PIC16C781/782 Rev. B3 Silicon/Data Sheet Errata

The PIC16C781/782 parts you have received conform functionally to the Device Data Sheet (DS41171A), except for the anomalies described below.

FIGURE 1: VOLTAGE COMPARATOR INPUT, MAXIMUM SLEW RATE AT V_{DD} = 5.5V, FAST MODE

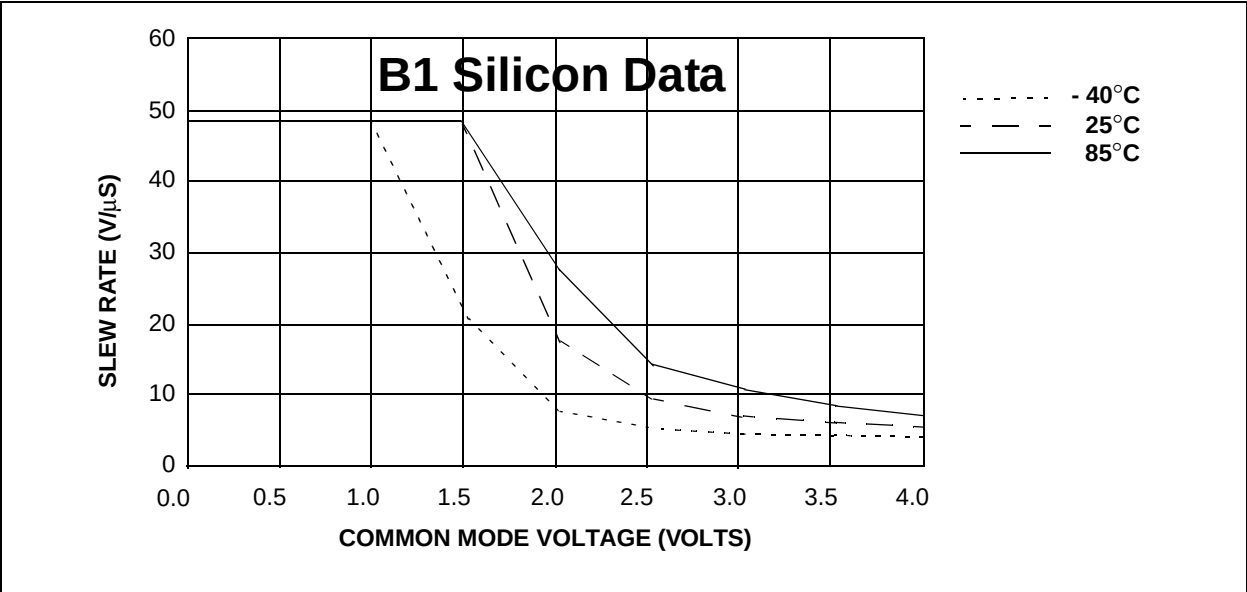
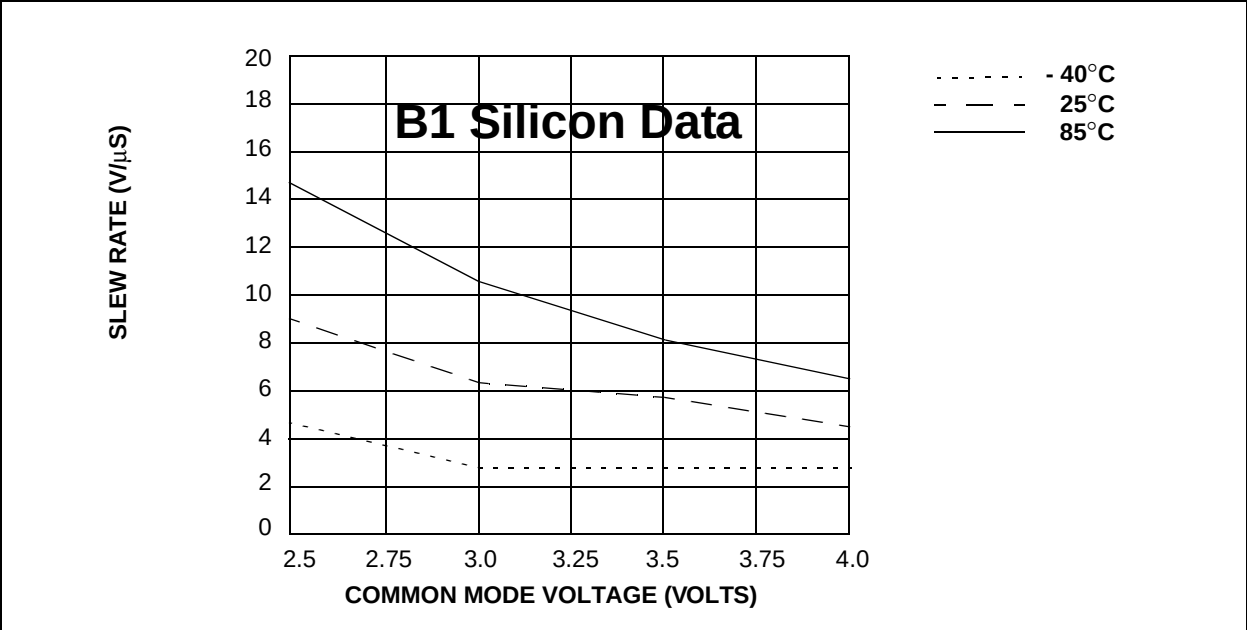
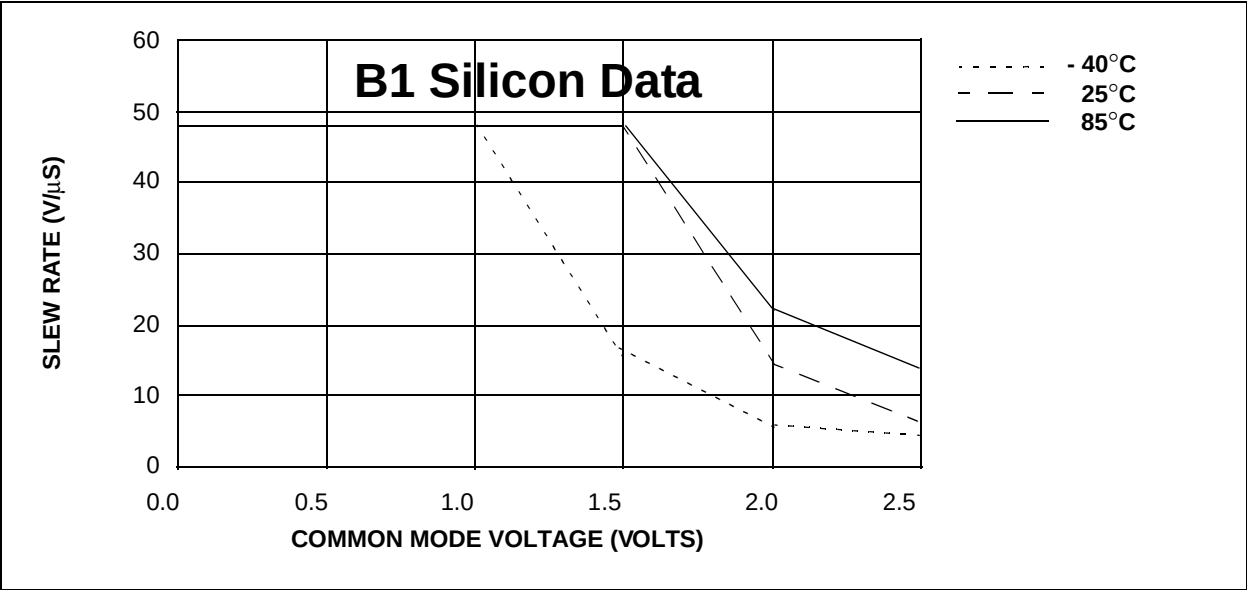
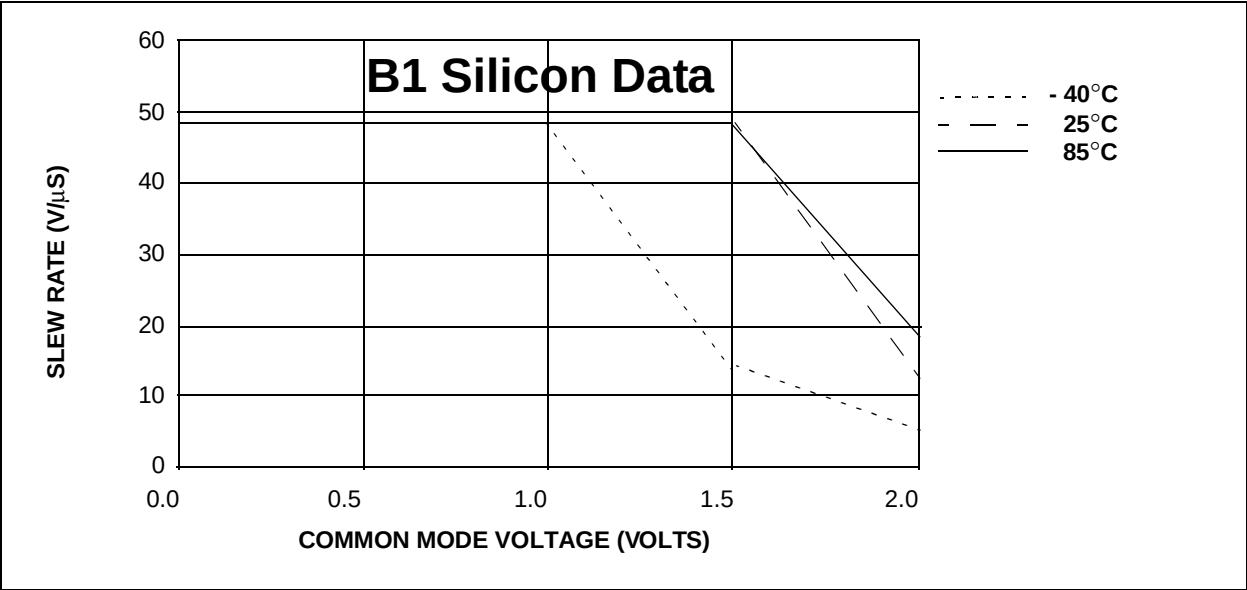
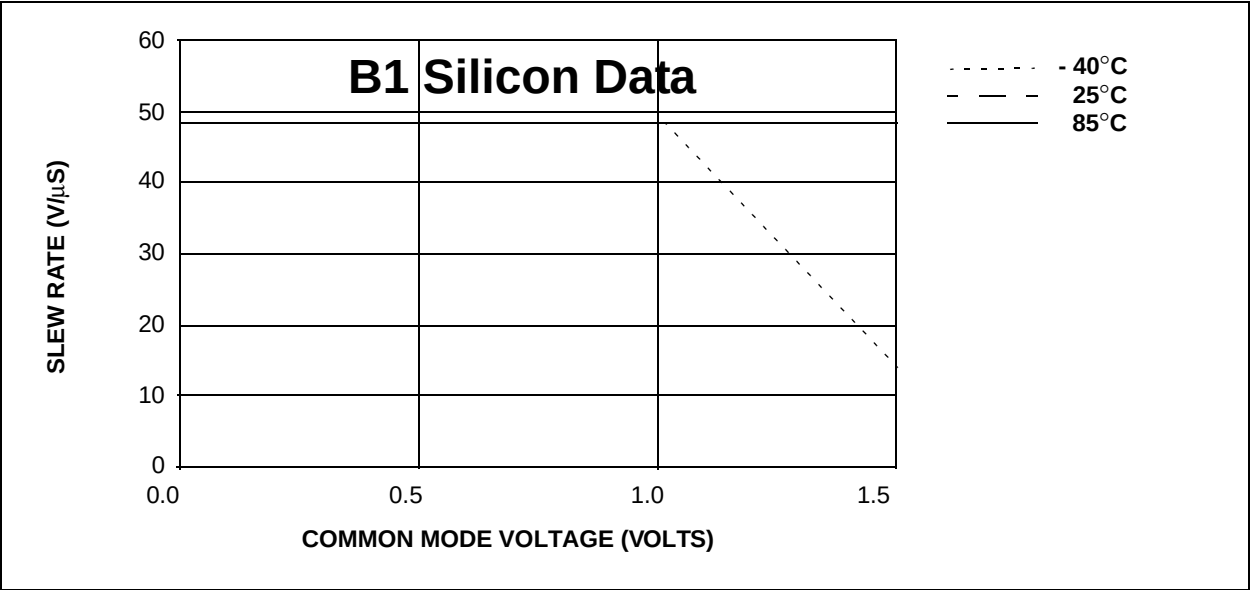
When the voltage comparator inputs are subjected to fast rise time pulses, some units exhibit a momentary invalid state on their output. The probability of generating an invalid output state is dependant upon four factors:

Figures 1 through 5 show the input slew rate limits for normal operation of the voltage comparators in Fast mode ($CMxCON0<3>=1$) for a variety of Common mode voltages, supply voltages and ambient temperatures.

If the PSMC is used in conjunction with the voltage comparators, an invalid voltage comparator output state can cause the premature termination of PSMC output pulses.

The pulse rise time of inputs to the voltage comparators should be less than the limits shown in Figures 1 through 5 for the specific conditions of operation (supply voltage, temperature, Common mode voltage). The values shown are for pulses with a constant rise time. For pulses with compound rise times (pulses with non-linear or changing slopes), the limits may be different.

Note: The area below the line for any given temperature is the safe operating area. Graph data is from B1 revision silicon. When B3 revision characterization data is available, the slew rate limits will be relaxed to reflect the improved performance of B3 silicon.

FIGURE 12-3: COMPARATOR C2 CONFIGURATION WITH OUTPUT SYNCHRONIZED TO TIMER1 CLOCK

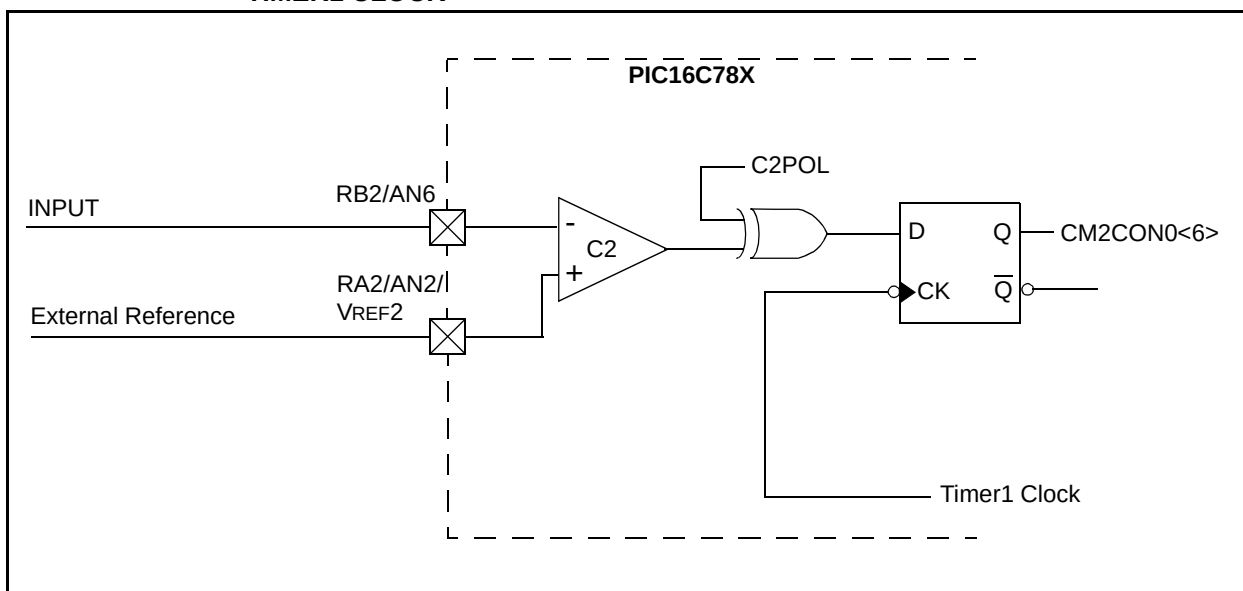
Correction to Figure 12-3 on page 95.

The synchronizing clock signal is supplied by the Timer1 clock, not the RA6 pin as shown in Figure 12-3.
